INFORMATION NOTE

N° 047/15

Implementation of a far dambar leadframe design for PG-DSO-28-22 as second source

Description of Change:

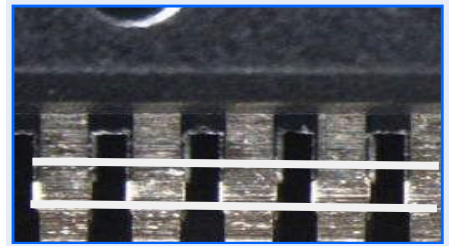
Subject of Change: Implementation of a far dambar leadframe design for PG-DSO-28-22 as second source

Reason of Change: Implementation of second source supplier

Old
close dambar

New (additional)
far dambar

Assessment: No impact on electrical parameters.
No impact for pick and place at board assembly expected.
